# UNITED STATES PATENT AND TRADEMARK OFFICE

APPLICATION NO.	FILING DATE	FIRST NAMED INVENTOR	ATTORNEY DOCKET NO.	CONFIRMATION NO.
10/615,133	07/08/2003	Mary Morabito O'Neill	02W234	8119

<b>Office Action Summary</b>	Application No.	Applicant(s)	
	10/615,133	O'NEILL ET AL.	
	Examiner	Art Unit	
	Troy Chambers	3641

## DETAILED ACTION

Fig. 4

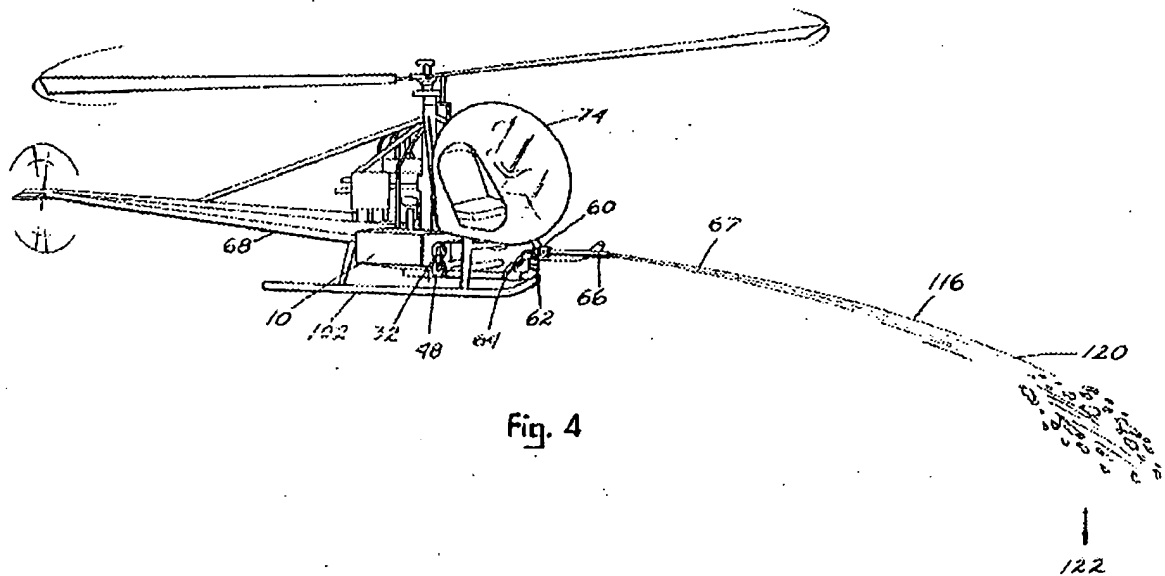
6. Claims 1, 2, 4, 6, 11, 14, 16, 22, 23, 24 and 26 are rejected under 35 USC 102(b) in view of US 4979571 issued to MacDonald. MacDonald discloses a method for obscuring an aircraft from infrared detection. Specifically, MacDonald discloses a foam producing apparatus for fighting fires comprising a helicopter as shown in Fig. 4 for transporting a pilot and fire retardant. A viewer at reference number 122 with infrared capabilities can see the heat given off by the engines of the helicopter. A mixture of CO<sub>2</sub> and water is used to put out fires (col. 6, ll. 41-66) at 122. A viewer at viewing location 122 would have its view of the engine heat (or exhaust plume) obscured by the flow of fire retardant. The obscurant is generated on the aircraft as shown at col. 6, ll. 41-66+. The method is capable of obscuring an auxiliary unit of the helicopter as well as the main engines. There is no disclosure of flares or infrared systems on the helicopter. The retardant is ejected from the front of the helicopter.

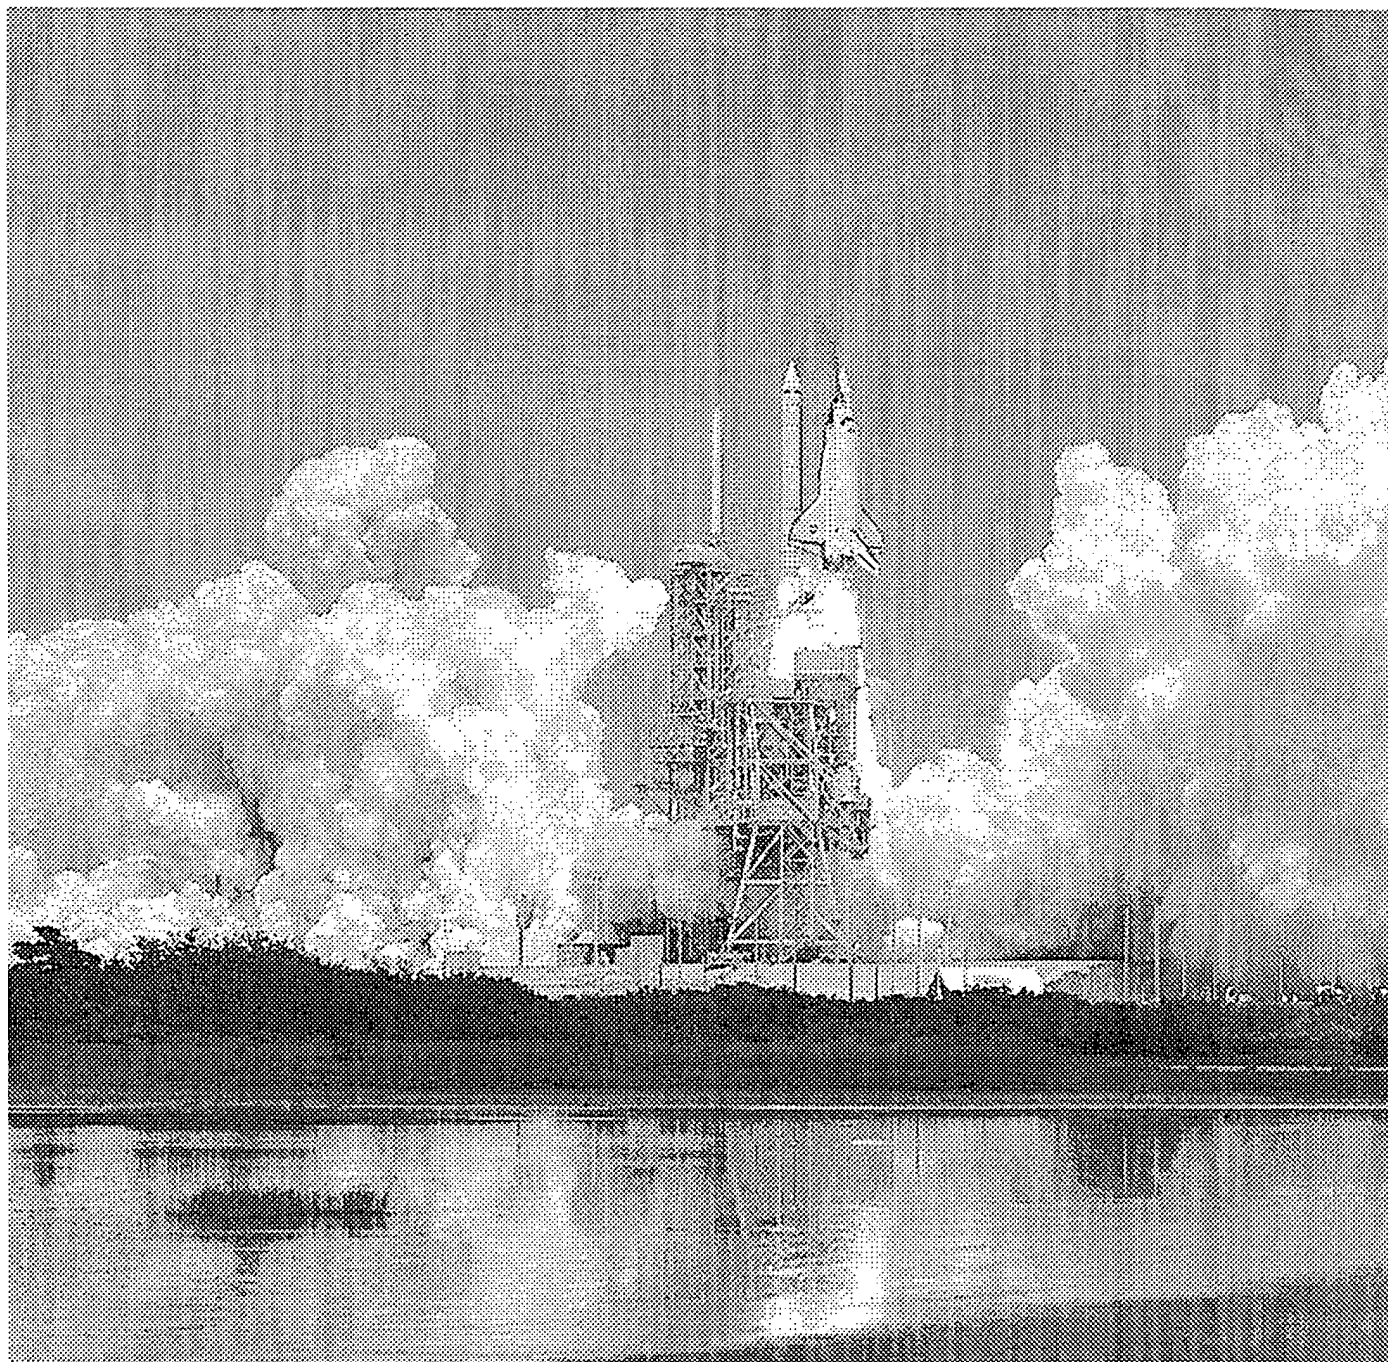
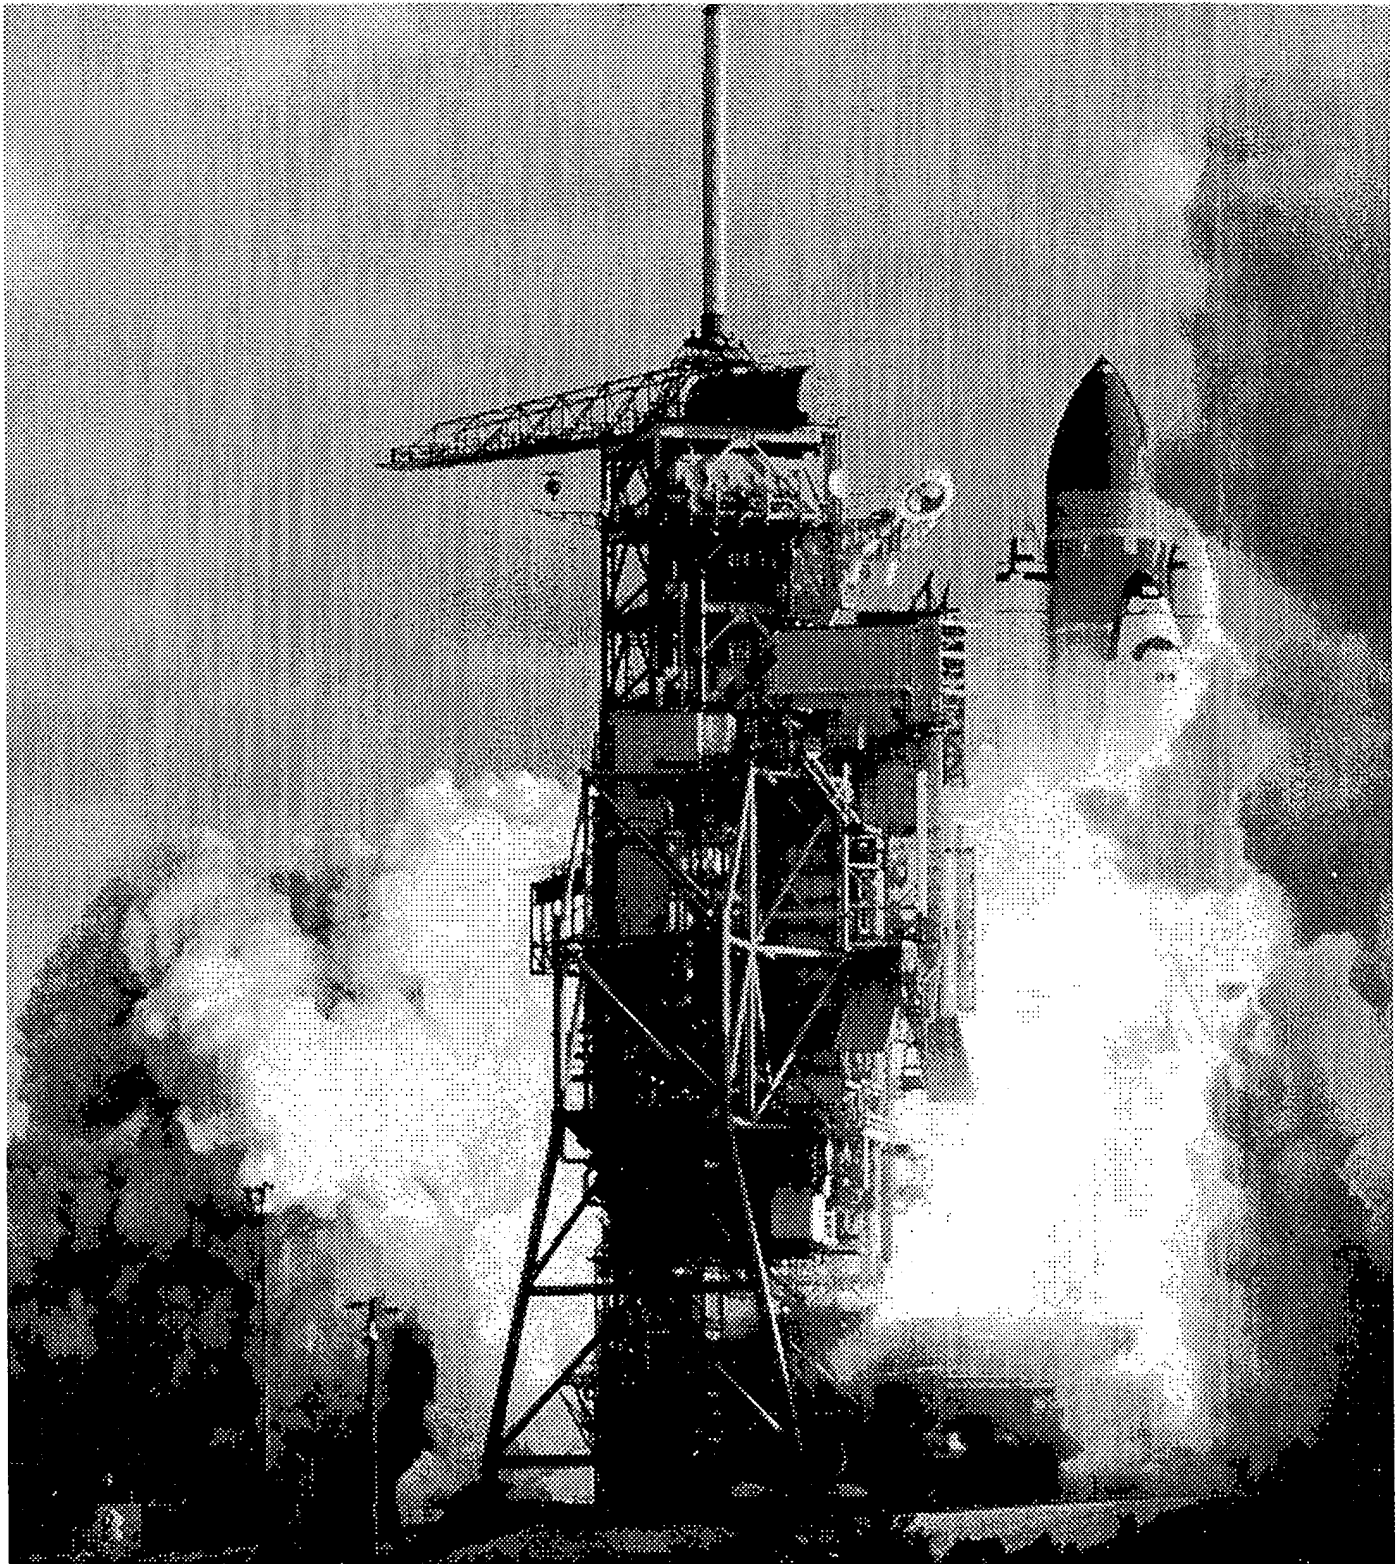
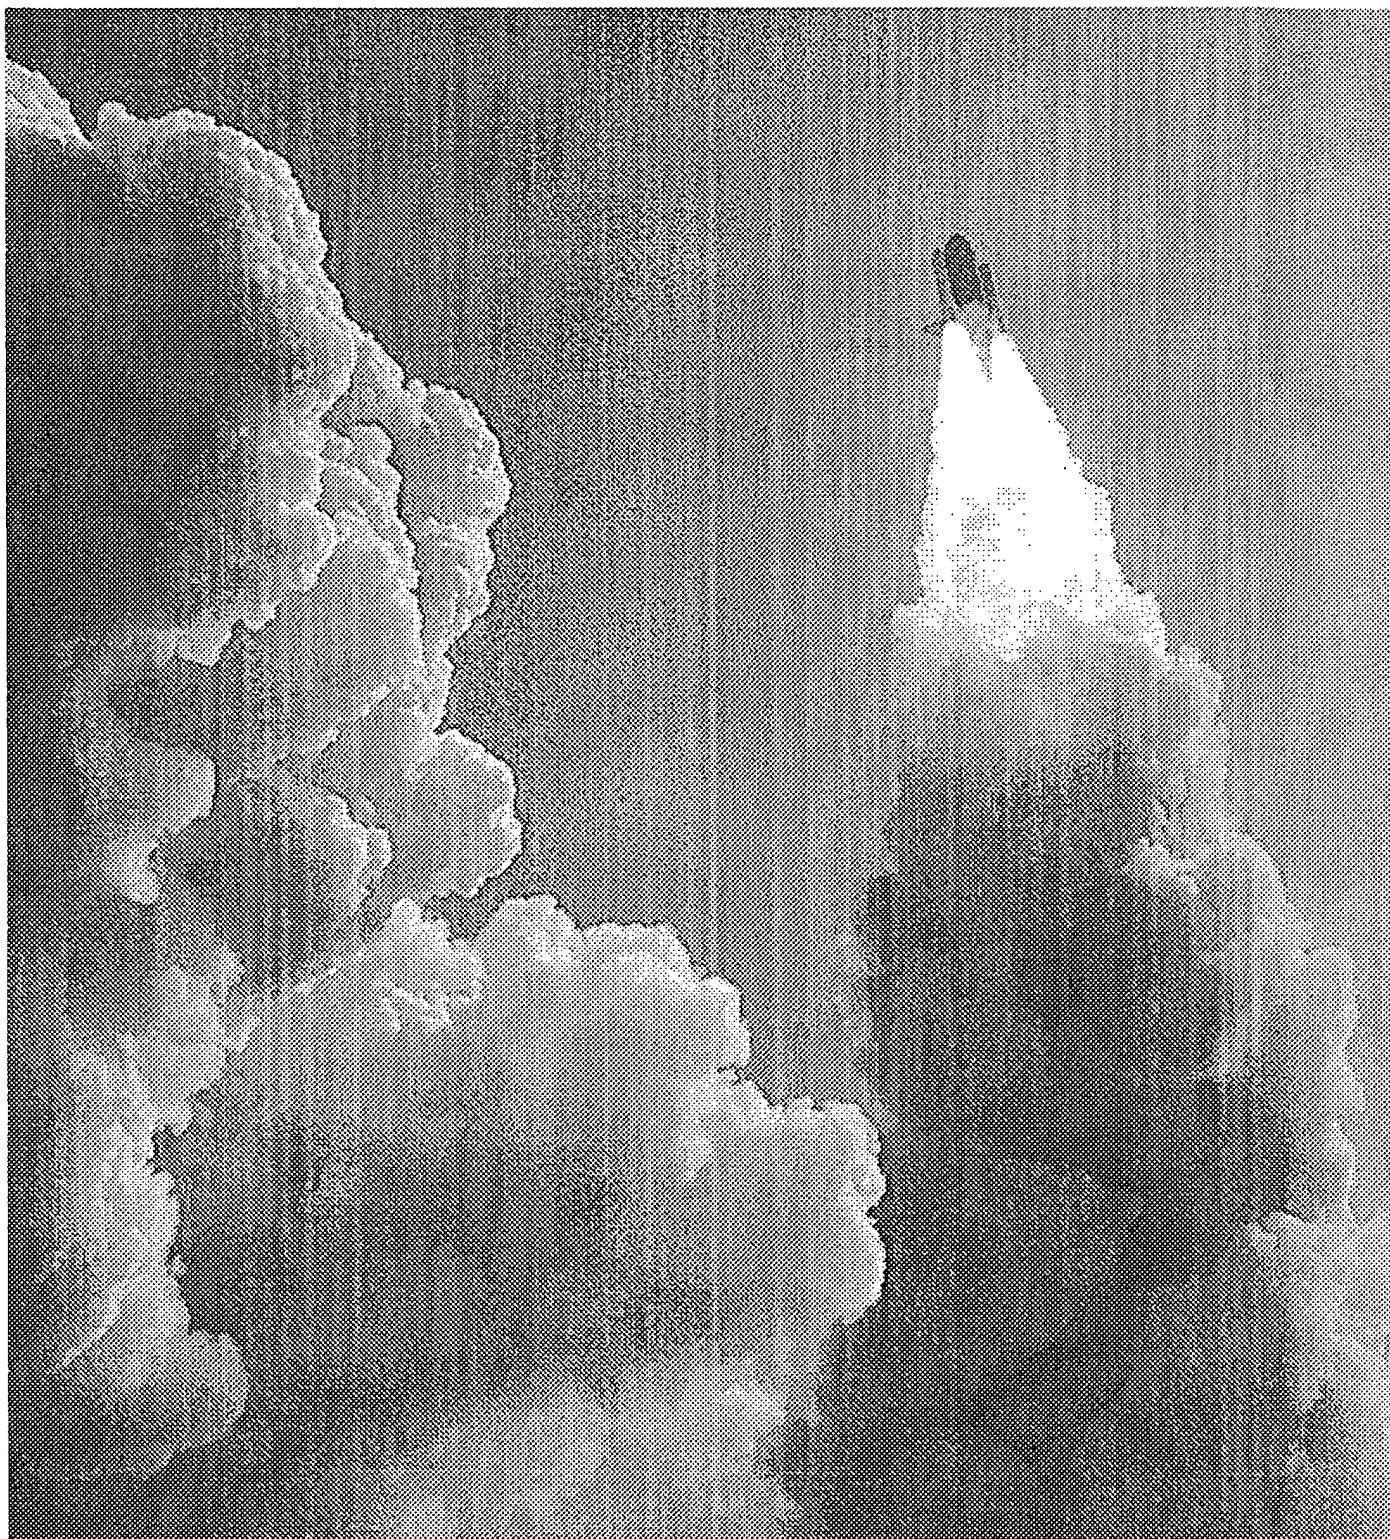
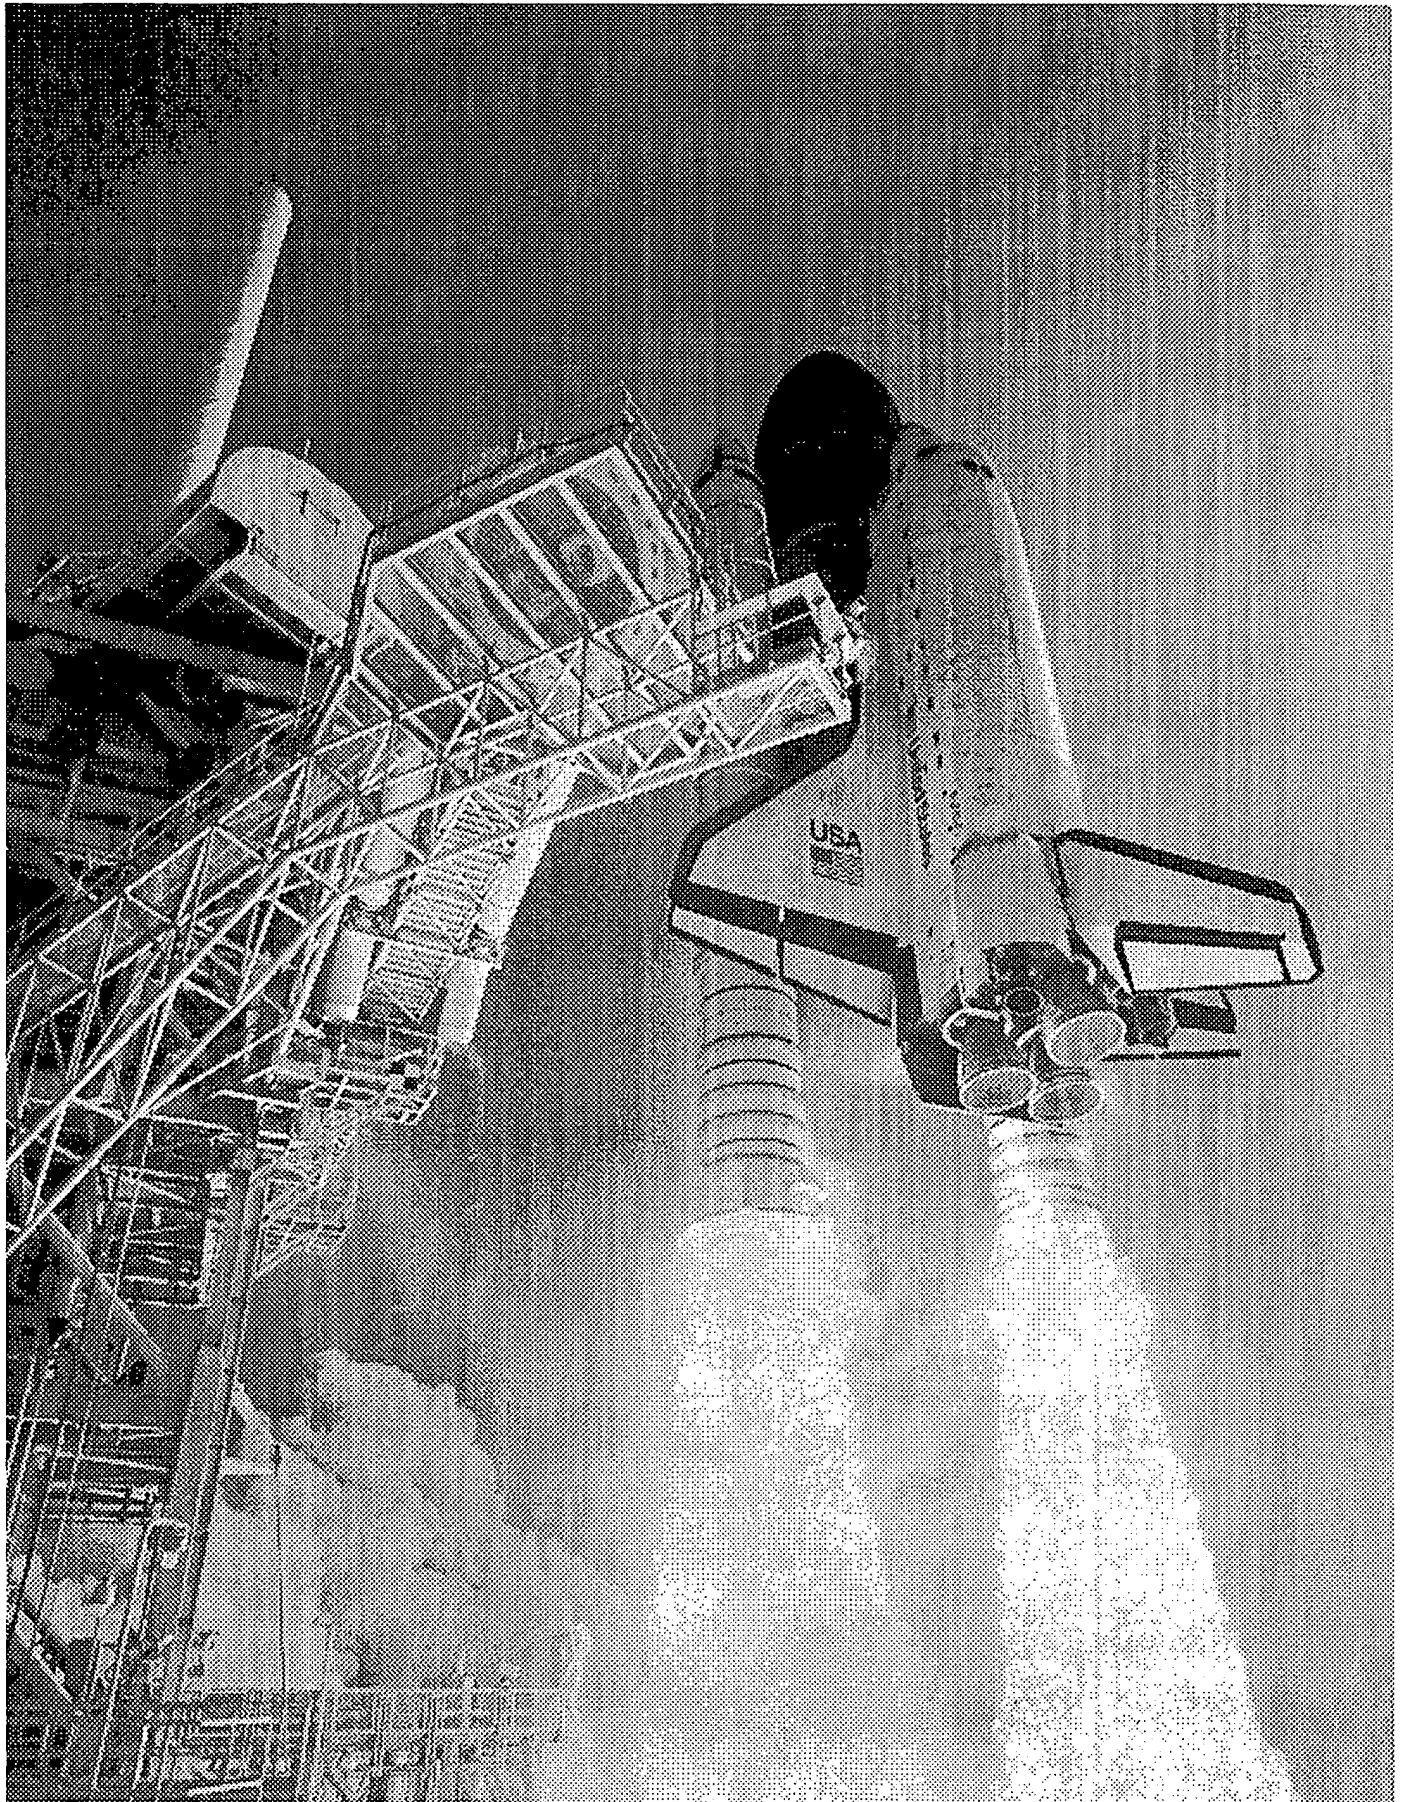
hydrogen, liquid oxygen and solid propellant (See any one of "Space shuttle main engine biography", "Solid Rocket Boosters", "How Space Shuttles Work" and "Space shuttle main engine"). At T minus 0 seconds the SRBs engines ignite the "source" of obscurant comprising solid propellant. As shown in the photos below, the shuttle is riding on a plume having a temperature greater than 150 degrees Celsius and is followed by great clouds of exhaust material, said exhaust inherently including traces of carbon dioxide and water vapor having a temperature less than that of the plume. As shown below, a viewer directly below or to the side of the shuttle during launch would have its view (infrared or otherwise) obscured by the clouds of obscuring agent.
